**TOWN OF CUTLER BAY  
DEVELOPMENT REVIEW COMMENTS**

**Project Name:** *Old Cutler Road Site Traffic Study*  
**Project Number:** *14-7174*

**Comments Based on 3<sup>rd</sup> Plan Submittal (Traffic Study dated July, 2017) and Trip Generation Analysis dated 6-5-19**

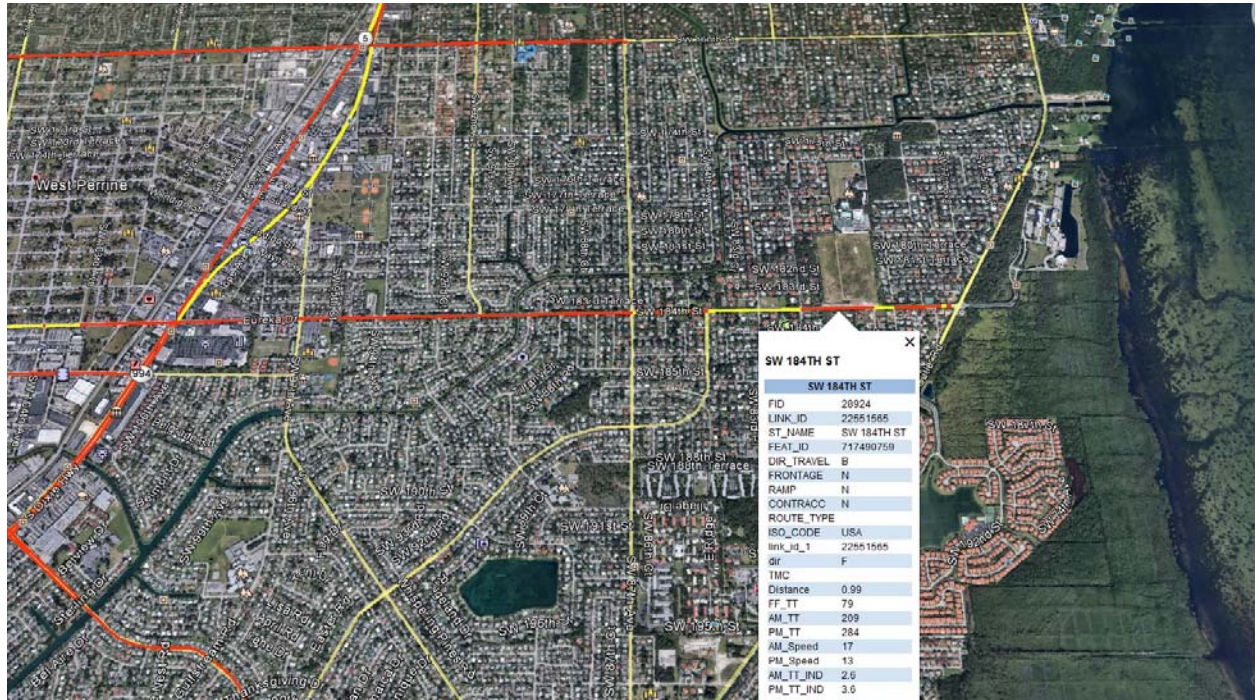
17. The Art Plan corridor analysis in the traffic impact study should include a sourcing of each of the input values that were used for each scenario. Please provide documentation in the Appendix for standard FDOT values for certain inputs if applicable (reference attached input reference sheet for typical inputs). Please ensure that data from the traffic counts collected (24-hour tube counts, manual turning movement counts) have been used to tailor each of the LOS corridor segment analysis. For instance, the percentage of left turns and right turns should correspond to the number of turns observed during the peak hour turning movement counts. The standard values per FDOT's

**CGA 05/05/17 Response: Please update data in table for the %Turns from Exclusive Turn Lanes table.**

*DPA 04/18/17 Response: A table has been prepared showing all the input values used in the ArtPlan analysis and is included in Appendix D. The analysis was revised to reflect these factors.*

*DPA 05/17/17 Response: The requested data is included as Attachment B. The ArtPlan reflecting these factors is also attached.*

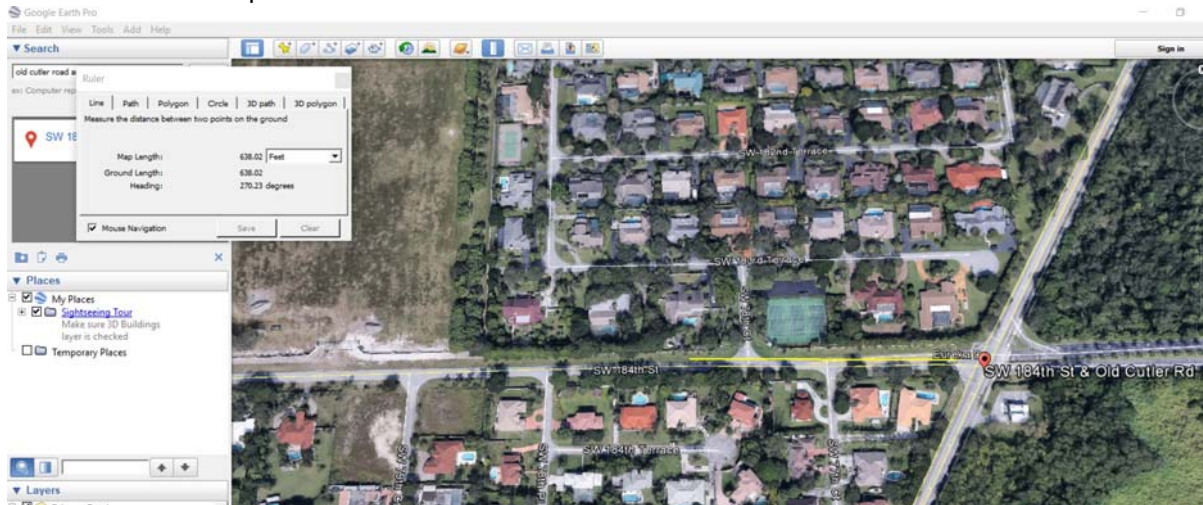
20. Please revise the FFS input in the Art Plan corridor analysis to be the posted speed limit. The roadway segments being analyzed are two lane facilities and the free flow speed will most likely top out at the posted speed limit and not 5 miles over the posted speed limit.

**CGA 05/05/17 Response: Please update ArtPlan analysis to include the posted speed limit in the input for the free flow speed (FFS).**

*DPA 04/18/17 Response: The ArtPlan analysis reflects the following posted speed limits: Old Cutler Road – 40 mph; SW 184<sup>th</sup> Street - 40 mph; and, SW 87<sup>th</sup> Avenue - 35 mph.*

*DPA 05/17/17 Response: The posted speed limit is included in the Segment (auto) input of the software. The output converts the speed limit to free flow speed automatically.*
